Subject: Duke Energy Carolinas, LLC

McGuire Nuclear Station, Units 1 and 2
Docket Nos. 50-369 and 50-370

Catawba Nuclear Station, Units 1 and 2
Docket Nos. 50-413 and 50-414

Amendment to Technical Specification 3.6.13, "Ice Condenser Doors,"
Revised Surveillance Requirements

Figure 6-128. Flow Area Pressure Differential

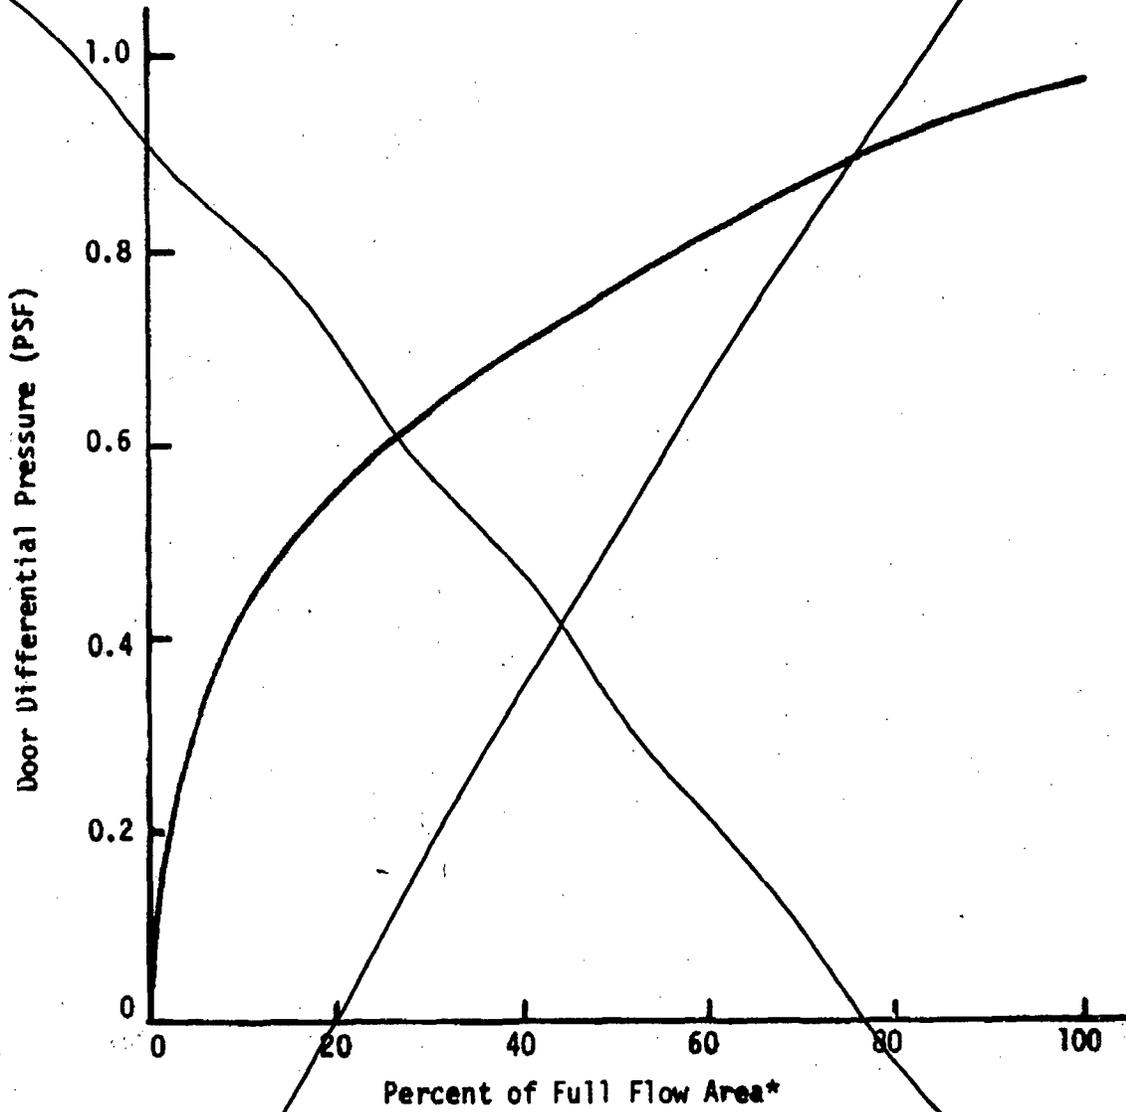
- ~~f. The Door System provide a flow proportioning capability for small break conditions in accordance with Figure 6-128.~~

~~Flow proportioning characteristics of the door are evaluated by determining the door opening as a function of applied pressure. Assuming a triangular pressure distribution across the door, the flow area vs pressure at full door opening, is determined to be consistent with the curve shown on Figure 6-128. In~~

DELETE

Figure 6-153. Flow Area - Pressure Differential

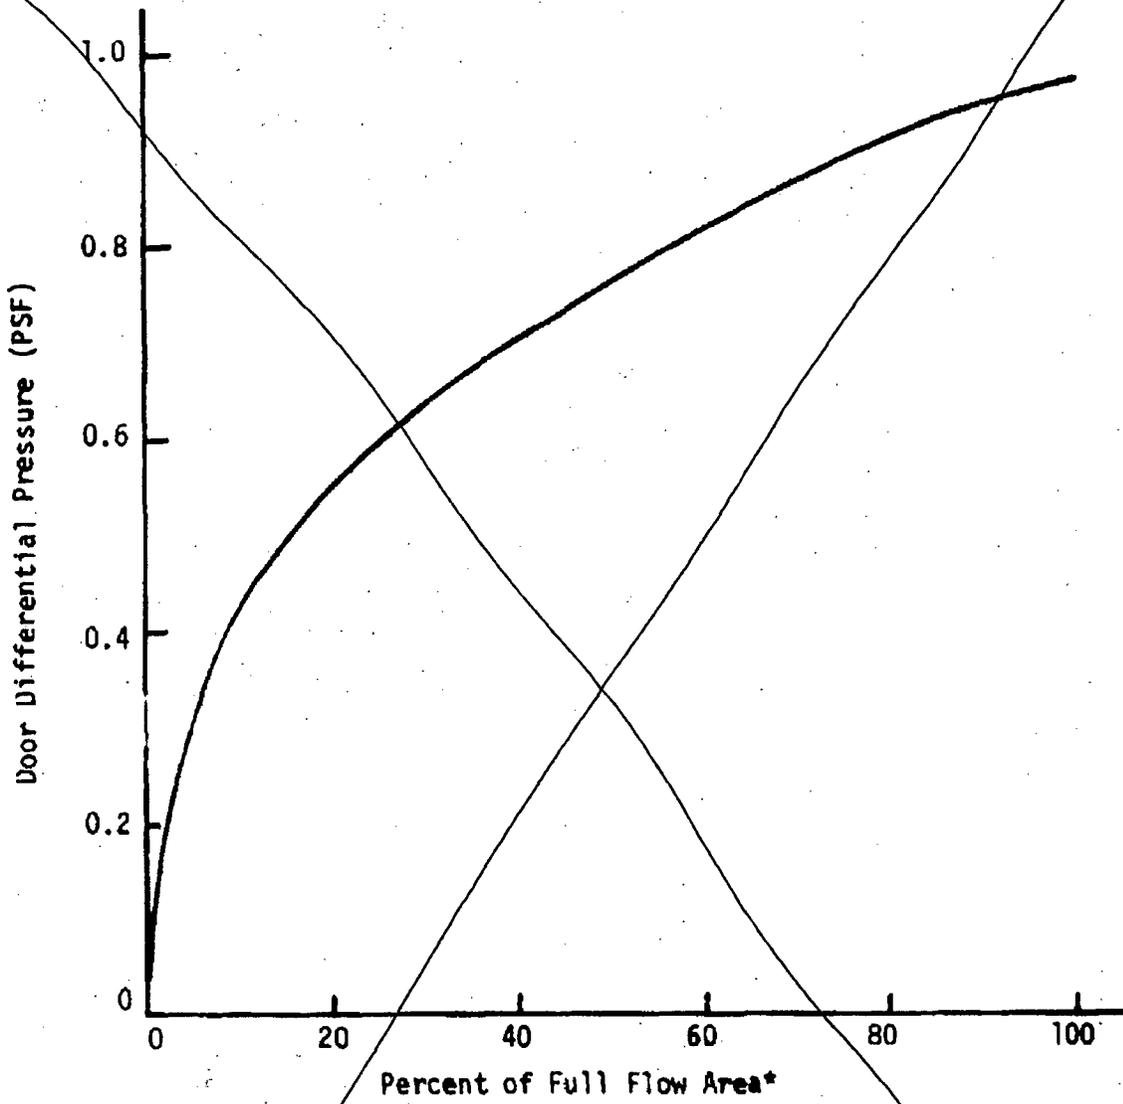
~~The Door System provides a flow proportioning capability for small break conditions in accordance with Figure 6-153.~~

~~Flow proportioning characteristics of the door are evaluated by determining the door opening as a function of applied pressure. Assuming a triangular pressure distribution across the door, the flow area vs. pressure at full door opening, is determined to be consistent with the curve shown on Figure 6-153. In addition, the effects of door closure were evaluated assuming the pressure is suddenly released from a fully opened door and the door allowed to shut under the effect of the door proportioning springs. Stress levels in the door, gasket, and frame are found to be acceptable for this condition. In addition to the above analysis, full scale simulated blowdown tests have been performed on prototype door and shock absorber assemblies. These tests confirm the adequacy of these components at test levels up to 140 percent of maximum loading conditions predicted by the TMD Code.~~

DELETE
